**DEPARTMENT OF THE ARMY**  
UNITED STATES ARMY GARRISON-ROCK ISLAND ARSENAL  
1 ROCK ISLAND ARSENAL  
ROCK ISLAND, ILLINOIS 61299-5000

**RESPONSES TO THE NUCLEAR REGULATORY  
COMMISSION MAY 20, 2004, REQUEST FOR ADDITIONAL  
INFORMATION REGARDING THE ENVIRONMENTAL  
MONITORING PROGRAM PLAN**

On May 20, 2004, the Nuclear Regulatory Commission (NRC) provided the U.S. Army with a Request for Additional Information (RAI) to support NRC's evaluation of the proposed changes to the Environmental Radiation Monitoring (ERM) Plan for Jefferson Proving Ground (JPG) dated September 2003. The RAIs address seven topics, as noted below:

Figure 1-1. DU Wells Within and Surrounding the DU Impact Area

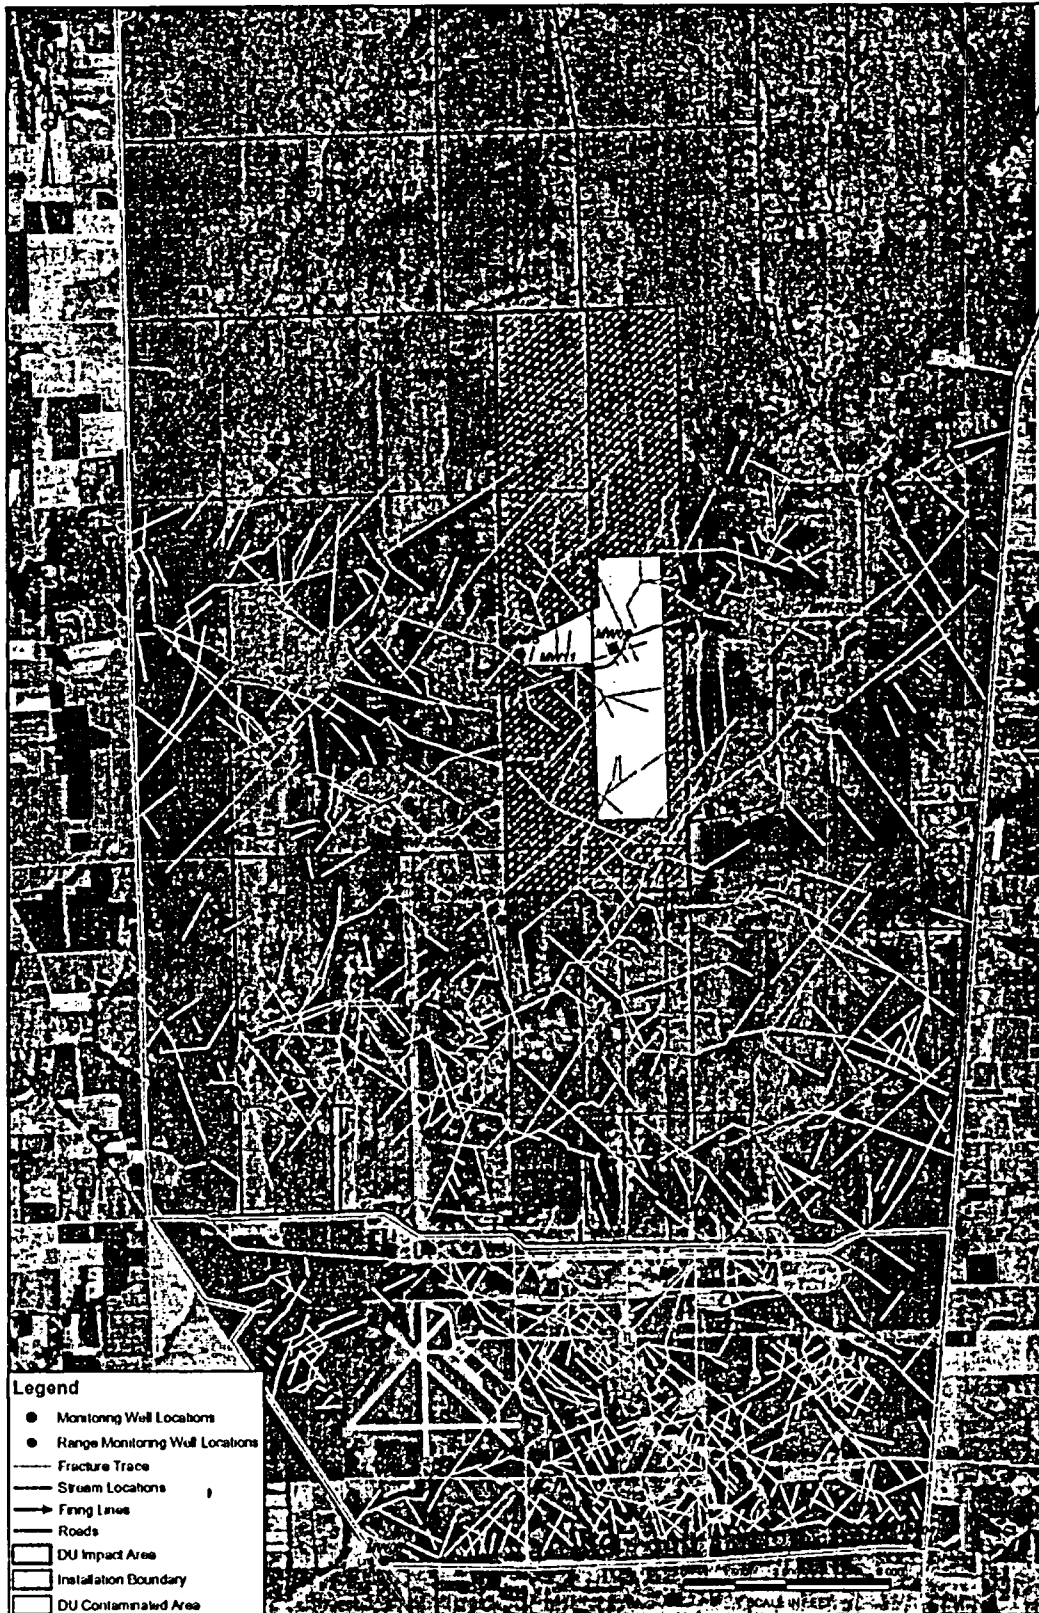
The Army should provide additional information on the conceptualized site model that was originally used to locate the sampling points for groundwater, surface water and stream sediments. The conceptual model of the hydrologic system for the DU Impact Area should include all potential water-bearing units, surface water systems, caves, springs, and the unsaturated zone that may be impacted by the degradation and movement of the DU penetrators. The Army should provide information on the interrelationship between DU concentrations in the groundwater, surface water, caves, springs and stream sediments.

- Assumed Darcian flow conditions. As a result, wells were placed accordingly, three in the up-gradient direction of the DU Impact Area (east side of impact area, MW-1, MW-2, and MW-3); three in the down-gradient direction (west side of impact area, MW-5, MW-6, and MW-7); and two in background locations (south of the firing line, MW-4, and MW-8).
- Located soil samples based on a grid pattern and included several background samples outside the impact area.
- Located surface water and sediment samples so that surface water entering (background) and exiting the impact area could be monitored. Two sample locations (one from each crossing stream) were located inside the impact area.

fracture trace analysis (Greeman 1981) documented numerous fractures and lineaments present within the DU Impact Area (see Figure 1-1).

Figure 5-1. Surface Area-to-Volume Relationship as a Function of DO Penetrator/Fragment Size

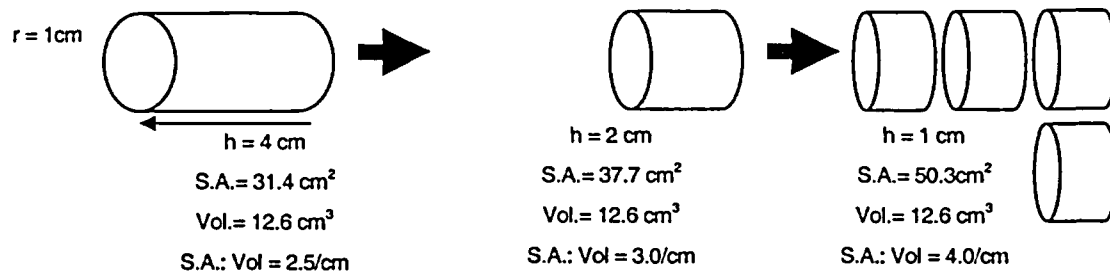
The Army should provide additional information on the rate of dissolution of the penetrators. The Army should also provide data on the solubility of DU.

<sup>1</sup> The surface area and volume were calculated by using the dimensions of the DU rounds provided in the report and the density of DU, 18.90 g/cm<sup>3</sup>.
